**SERVICE BULLETIN**

**N° 139-557**

**ATA 25 – HOIST CABLE CUTTER FRAME INSTALLATION**

Revision A is issued in order to cancel this Service Bulletin.

**Figure 1**

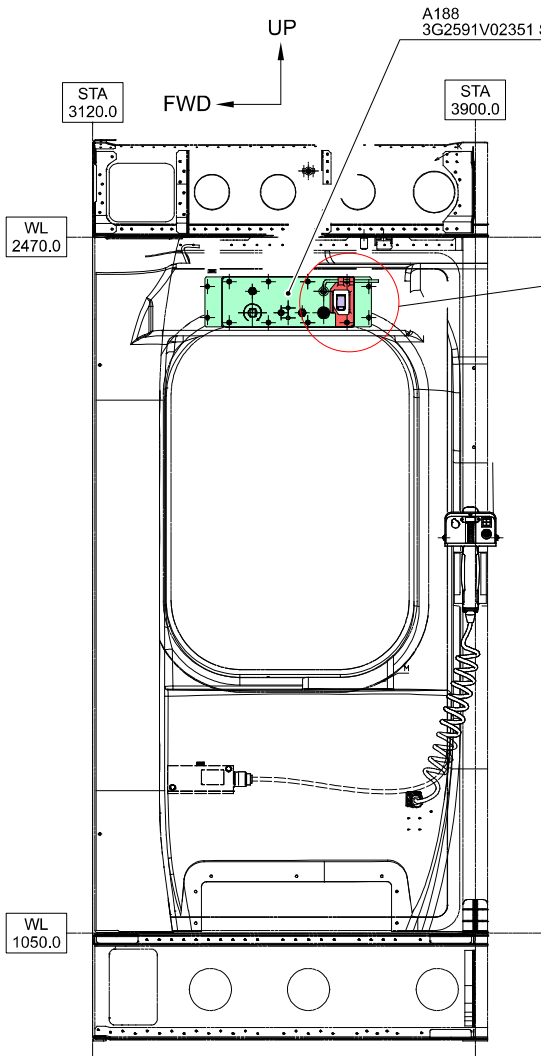
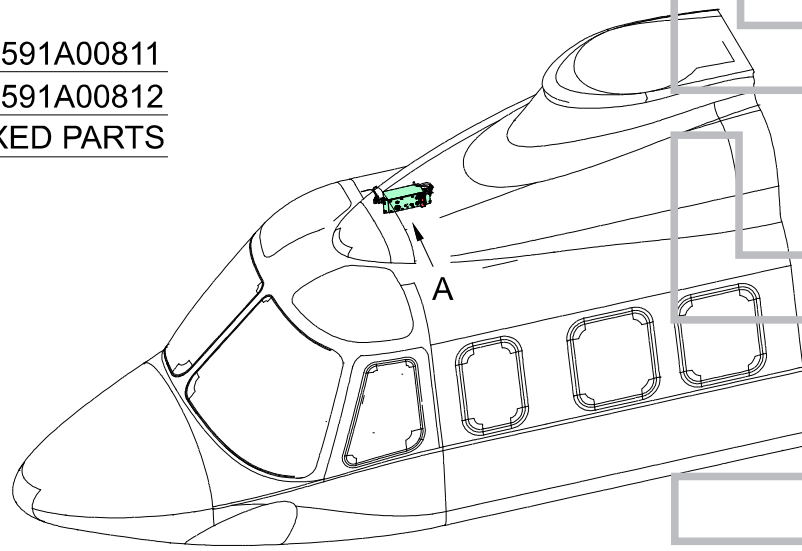
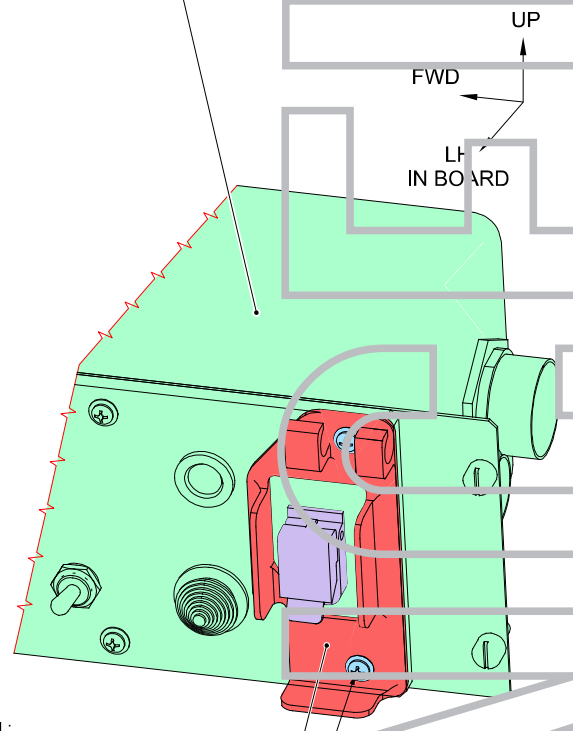
2. With reference to Figure 1, gain access to the cabin.
3. With reference to Figure 1 View A Detail B, remove and retain for later reuse n°2 existing screws from the single hoist control panel P/N 3G2591V02351.

4. With reference to Figure 1 View A Detail B, apply locking compound AN3311 to the threads of the screws removed at previous step.
5. With reference to Figure 1 View A Detail B, install the hoist cable cutter frame P/N 3G2591A08851 on the single hoist control panel P/N 3G2591V02351 by means of n°2 screws previously removed; torque the screws to  $0.54 \pm 0.68$  Nm.

6. With reference to Figure 1 View A Detail B, coat the screw heads with "matt black" polyurethane coating.
7. Return the helicopter to flight configuration and record for compliance with Part I of this Service Bulletin on the helicopter logbook.

A188  
3G2591V02351 SINGLE HOIST CONTROL PANEL (REF)

INSTALL:  
3G2591A08851 FRAME HOIST CABLE CUTTER

USE:  
EXISTING SCREWS (2 OFF)  
APPLY:  
AN0311 LOCKING COMPOUND  
POLYURETHANE COATING  
TORQUE TO:  
0.54+0.68 Nm

**Figure 2**

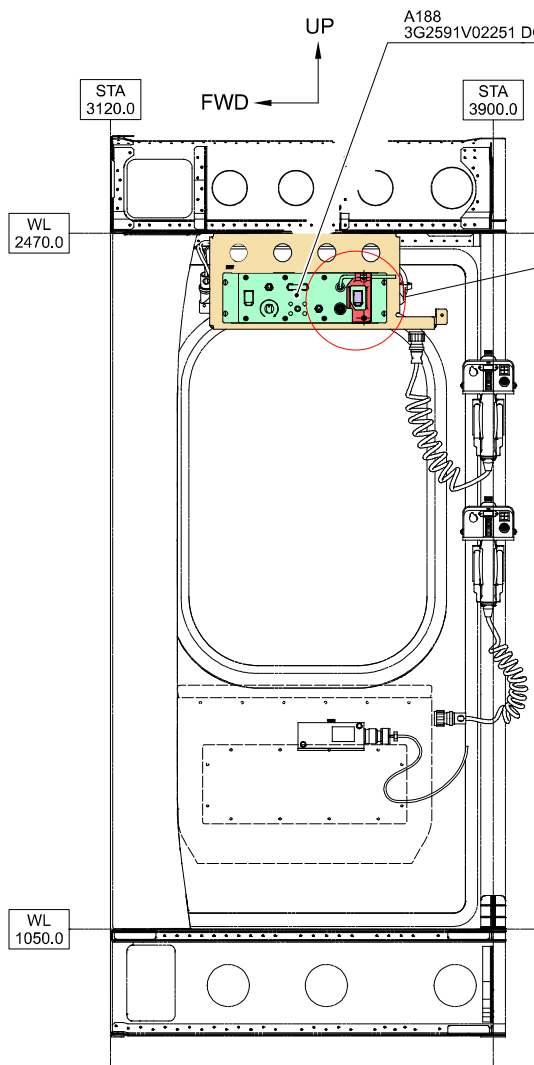
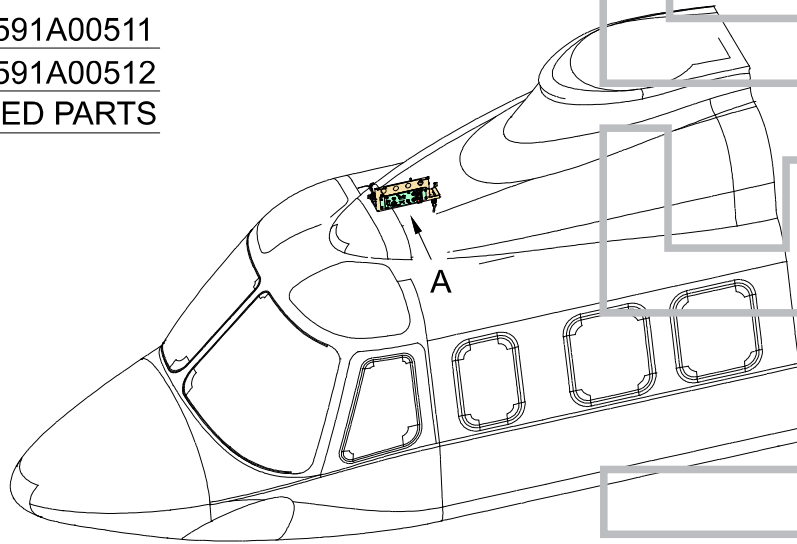
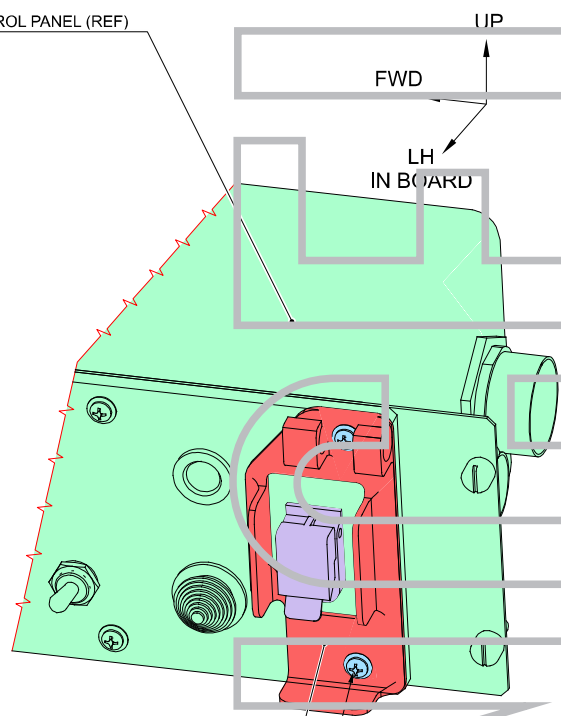
2. With reference to Figure 2, gain access to the cabin.
3. With reference to Figure 2 View A Detail B, remove and retain for later reuse n°2 existing screws from the double hoist control panel P/N 3G2591V02251.

4. With reference to Figure 2 View A Detail B, apply locking compound AN0311 to the threads of the screws removed at previous step.
5. With reference to Figure 2 View A Detail B, install the hoist cable cutter frame P/N 3G2591A08851 on the double hoist control panel P/N 3G2591V02251 by means of n°2 screws previously removed; torque the screws to 0.54÷0.68 Nm.

6. With reference to Figure 2 View A Detail B, coat the screw heads with “matt black” polyurethane coating.
7. Return the helicopter to flight configuration and record for compliance with Part II of this Service Bulletin on the helicopter logbook.

INSTALL:  
3G2591A08851 FRAME HOIST CABLE CUTTER

USE:  
EXISTING SCREWS (2 O F)  
APPLY:  
AN0311 LOCKING COMPOUND  
POLYURETHANE COATING  
TORQUE TO:  
0.54+0.68 Nm
